297 Te Puna Station Road

Proposed Industrial Development

OPERATIONAL NOISE AND VIBRATION S92 QUERIES

Reference: J005252.S92.1

Figure 1 - Cross Section of the Workshop at Alternate Location (N-S Section facing West)

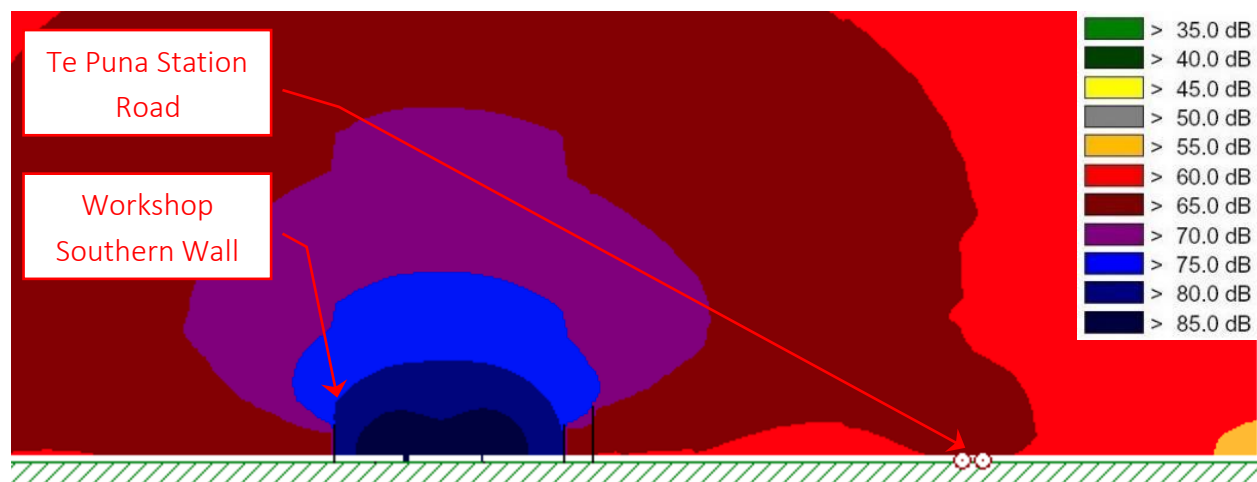
1. What reduction in noise is the fabric roofed workshop area assumed to provide to workshop noise within the model?

The proposed fabric roofing of the workshop area was disregarded acoustically. It was assumed to have no effect on noise propagation, and as such, the workshop was modelled without a roof (i.e. wall shielding only.) The following cross section from the modelling is representative of the noise propagation from the workshop.

Predicted Noise Levels (Daytime Compliance) – Full Activities at Container Operation –
Alternative Workshop Location – No Public Traffic

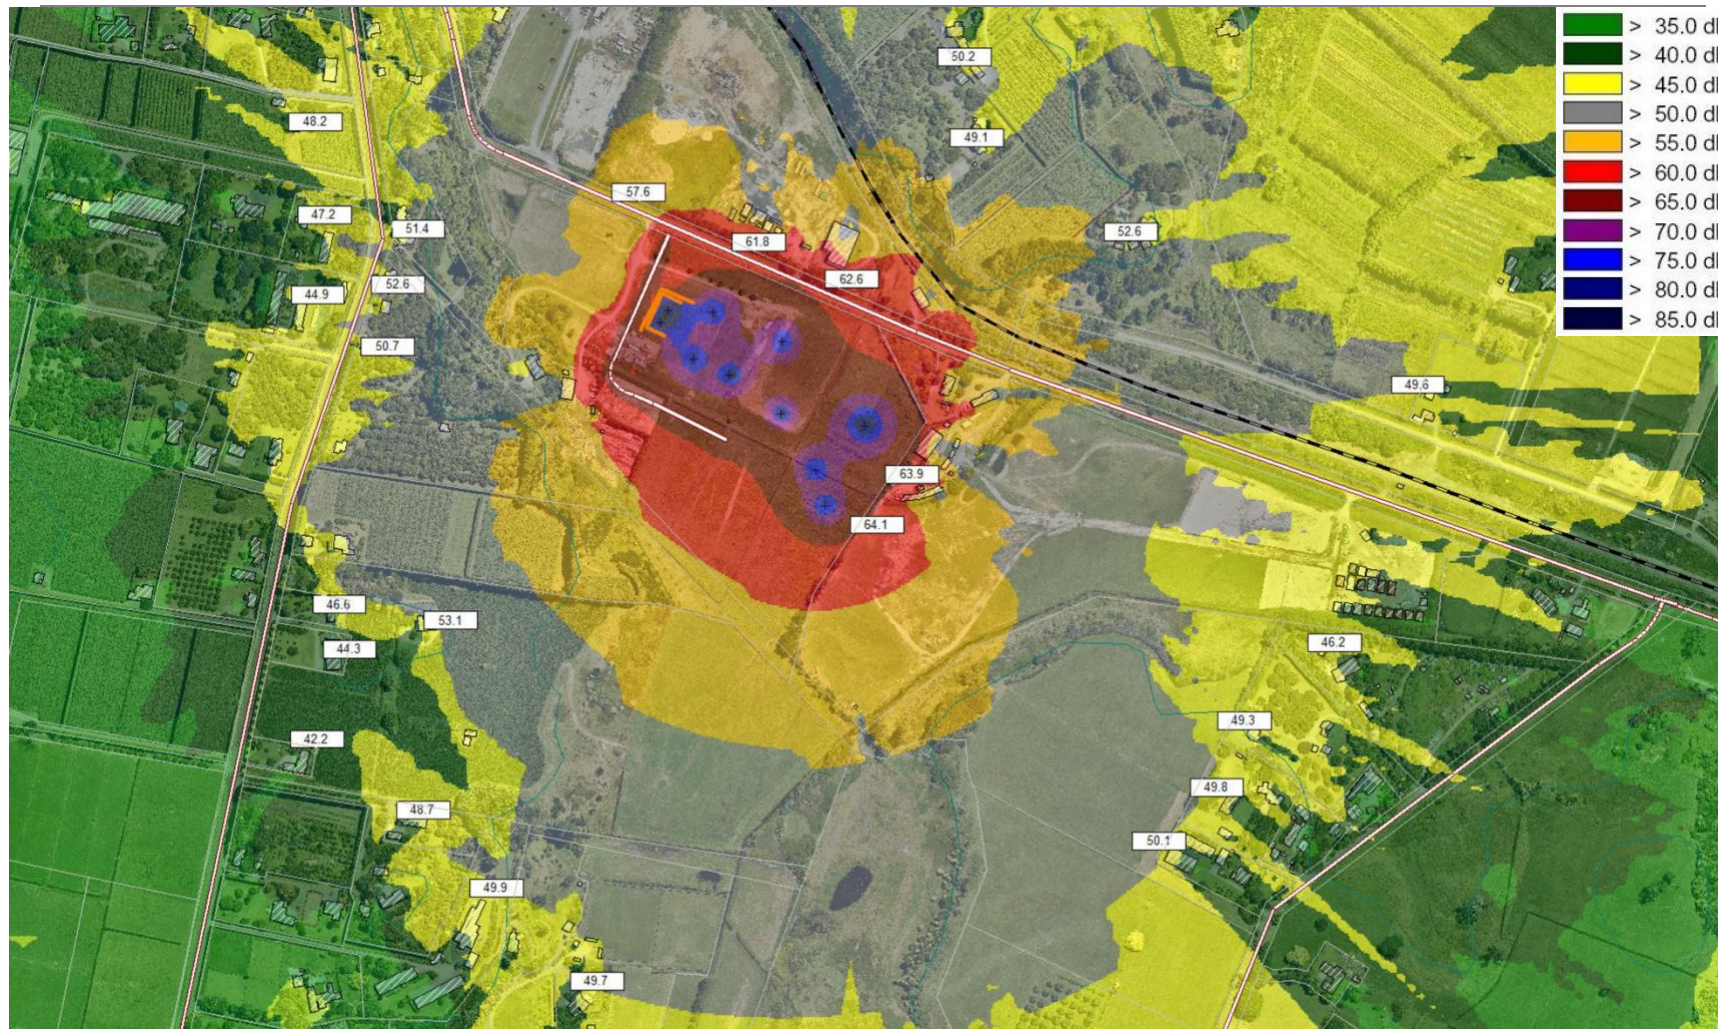
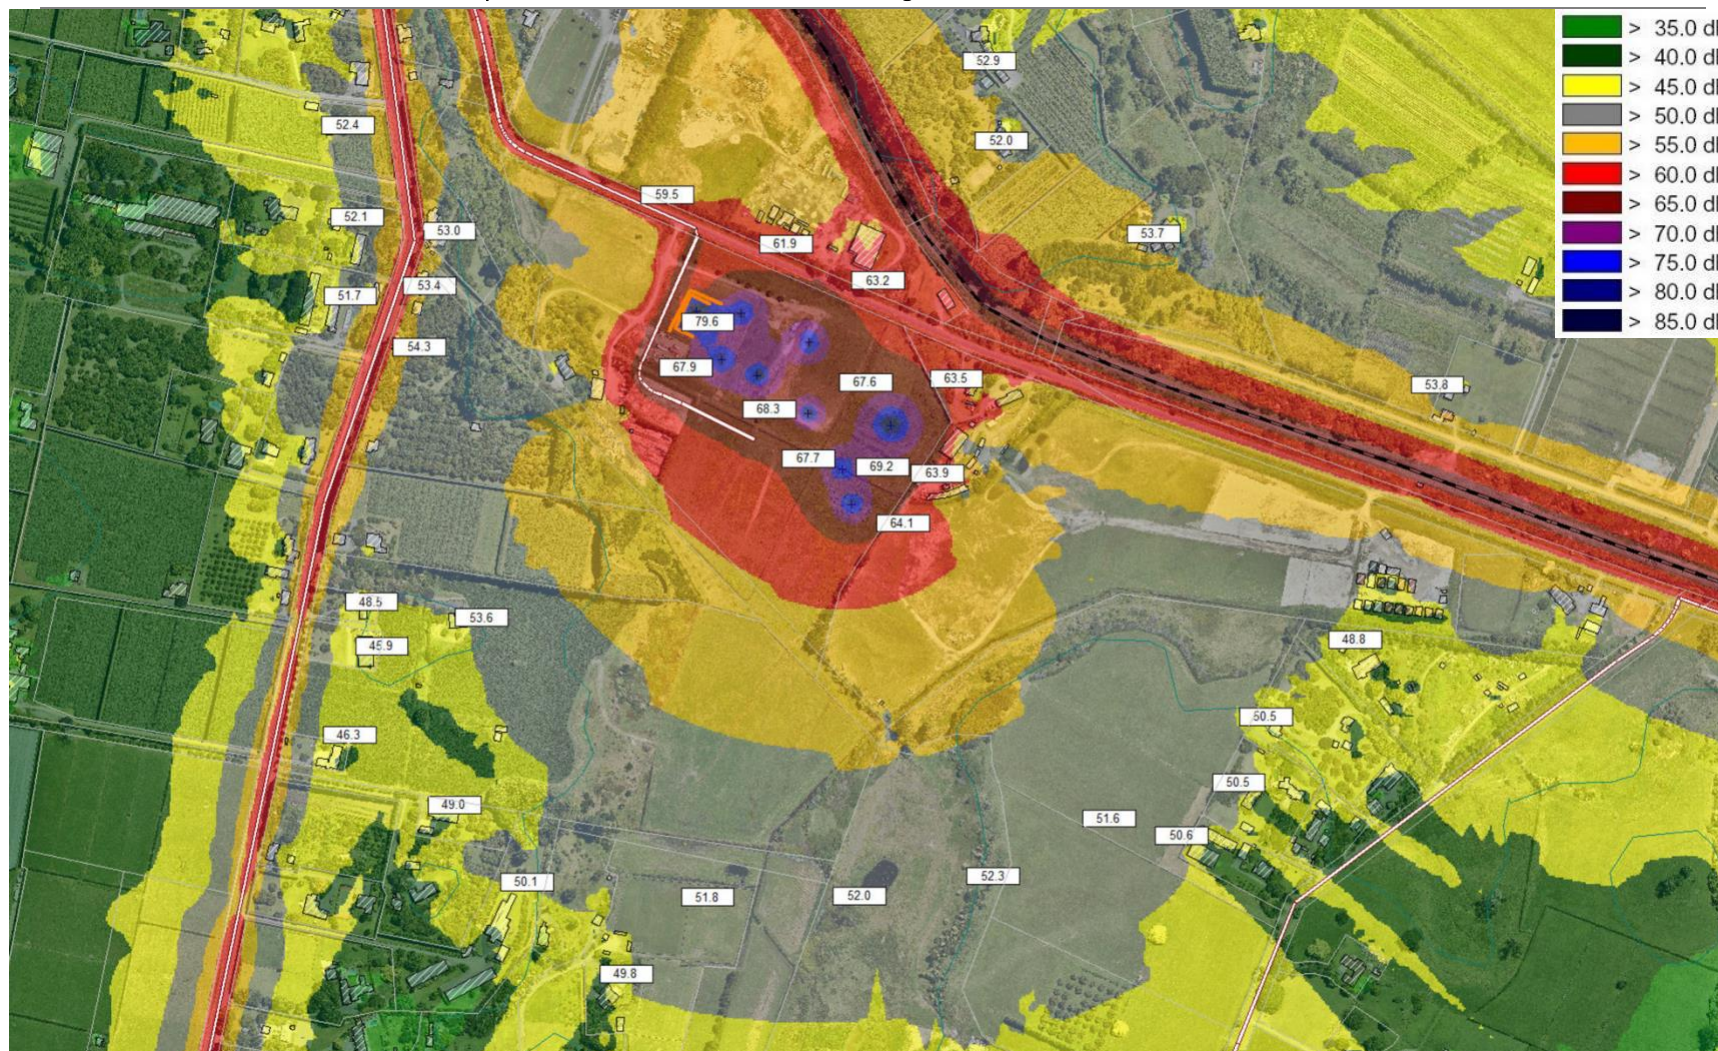
4. Please provide a table of predicted noise levels at the notional boundary of receivers (day and night) from activities only occurring within the site boundary.

The diagrams in the following pages are representative of predicted noise levels from the operation of the site only (disregarding all existing noise sources and ambient noise.) The numerical values in rectangles are representative of the predicted noise levels at notional boundaries (or boundaries in the case of industrial zones) of each receiver.

We note the predicted noise levels would be within the compliance limits at all receivers during all times.

Figure 2 - Sample Cumulative and Individual Noise Limits - Demonstration Only

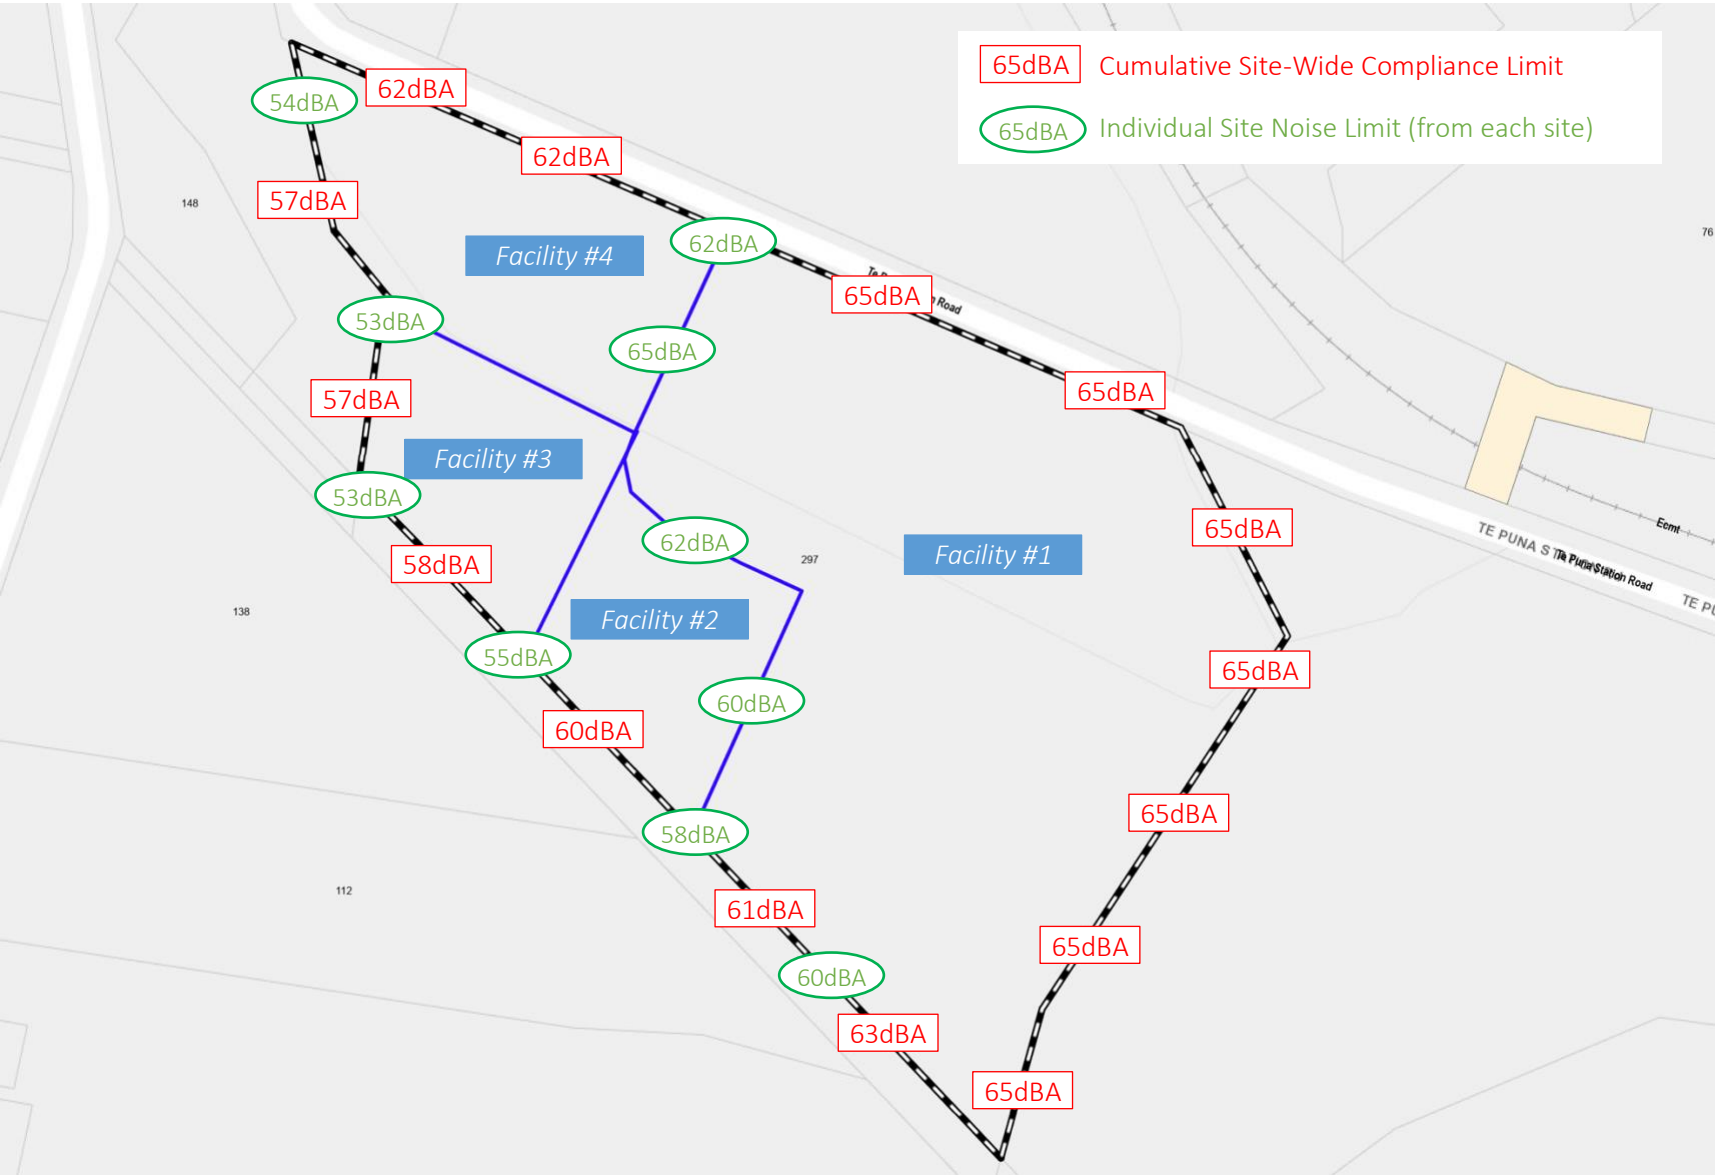
1. It is not clear how the overall management of noise from the site would take place. An example noise management plan may assist in understanding how they would all interact together as proposed.

2. How will it be made clear in NMPs who is ultimately responsible for ensuring the plan(s) is/are implemented and where the overall 'noise budget' will be retained / confirmed for other NMPs. This is especially important given the proposal for multiple activities operating independently – further clarity on this matter should be provided.

The example on the page below is of a noise map for the site covering example compliance noise limits at the boundaries both cumulative and specific to different operations. This is based on the first operation being the Container facility and each of the other facility having noise sources at circa 25m from the boundaries.

For example as per the figure below, each of Facility #2 and #3 can only generate 55 dBA near the boundary between them at the southern site boundary. This would result in the cumulative noise from them and the other facilities to be within compliance at the receivers (cumulatively 60dBA at the southern boundary.)
